Product discontinuation notification (PDN)

Title / short description	Product discontinuation as a part of portfolio streamlining
Affected article category	Electronic switching devices and motor control
Change category	Discontinuation
Change number	ICK240003_1-00
Reason for PCN/PDN Revision

ICK240003-00_1
Sample: block diagram

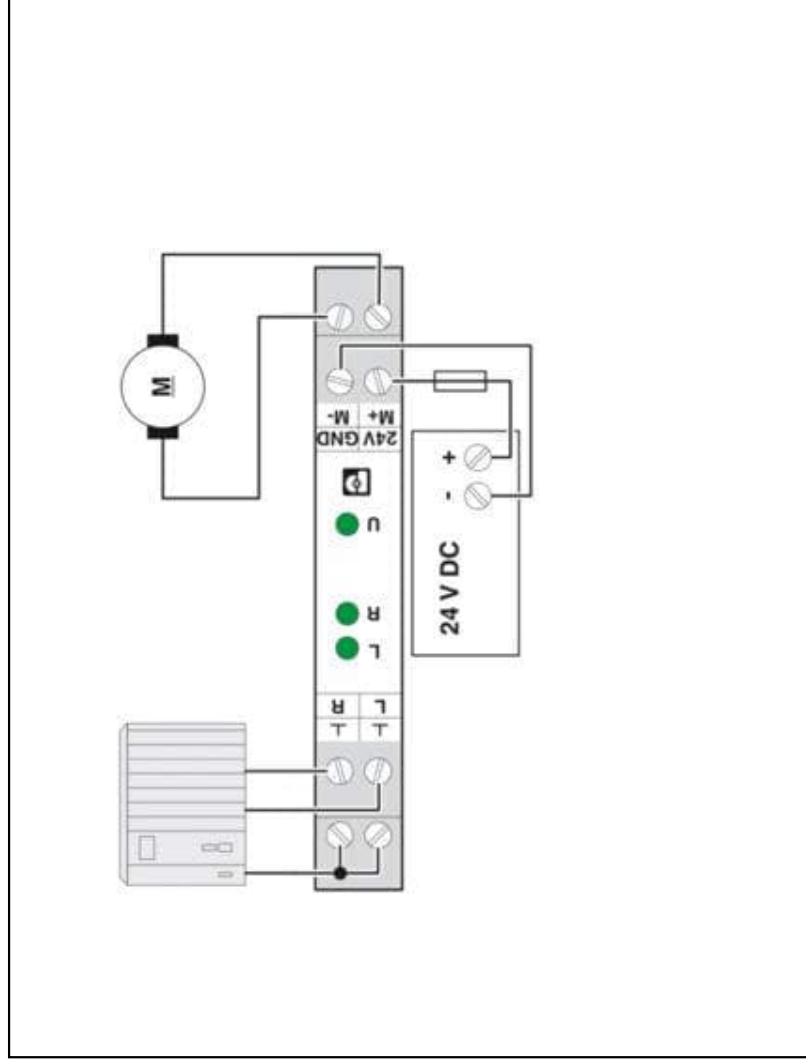
Bisheriges Blockschaltbild
Current block diagram

Neues Blockschaltbild
New block diagram

ICK240003-00_1
Sample: housing

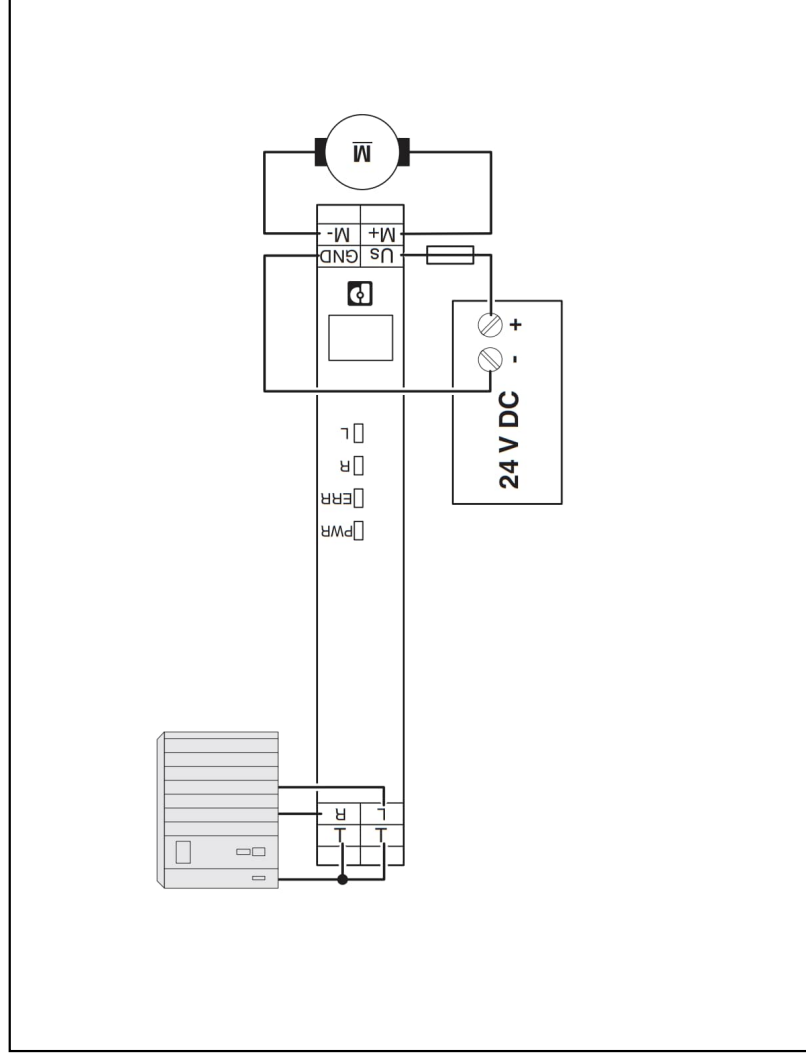
Bisheriges Gehäuse
Current housing

Neues Gehäuse
New housing
